Notice of Allowability	Application No.	Applicant(s)
	10/521,670	HUGHES, JOHN B.
	Examiner	Art Unit
	Peguy JeanPierre	2819

DETAILED ACTION

Fig. 10

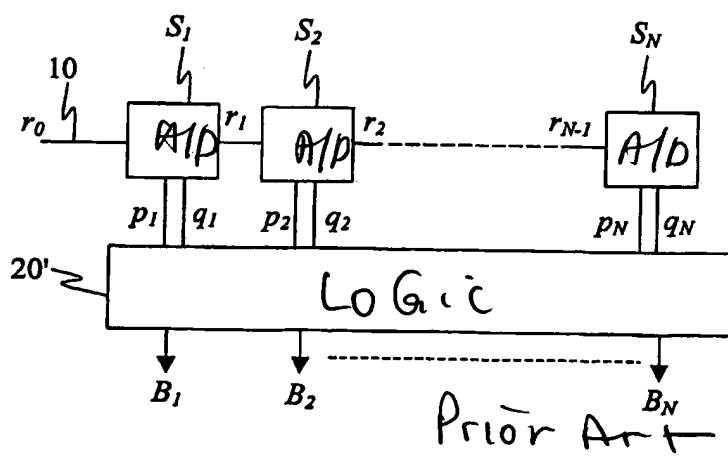
1. The drawings are objected to because the blocks in Figures 1, 2, 8, 10, and 12 are not labeled.

2. Figures 1, 2, and 10 should be designated by a legend such as --Prior Art-- because only that which is old is illustrated. See MPEP § 608.02(g).
